MOTORCYCLE DOCTOR LLC

Date:
03-28-2018

Hello to HiSun Engineer, this fix is to solve a Wet Shoe Clutch problem that many MTD / Cub Cadet dealers are complaining of chatter noise, excessive wear and internal Wet Shoe, Clutch Drum and 1-Way Bearing failure.

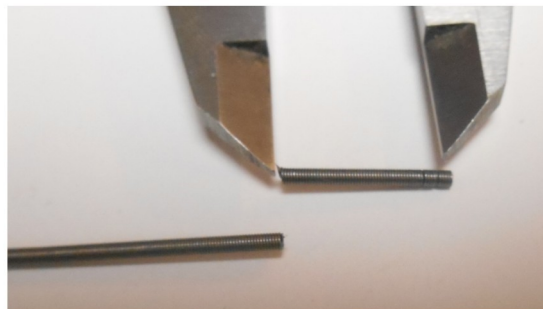
The lighter mass of the new 'Rare Earth Magnets' on the rotor allow a the whole crankshaft assy. to pulsate fast/slow and this makes the 1-way bearing to 'Lock and Unlock' because the Wet Shoe is Pulsating which makes the Sprag Prawl Bearings inside the 1-Way bearing to open too easy, causing the excess wear and failure.

We have solved this problem by removing approx 15mm of spring length. This adds tension to keep the prawls from chattering and wear. See below.

Remove spring,
twist off connection.

Cut off approx. 15mm, push and twist together, install.

Please replace this stock spring with a Higher Tension Spring before assembly.
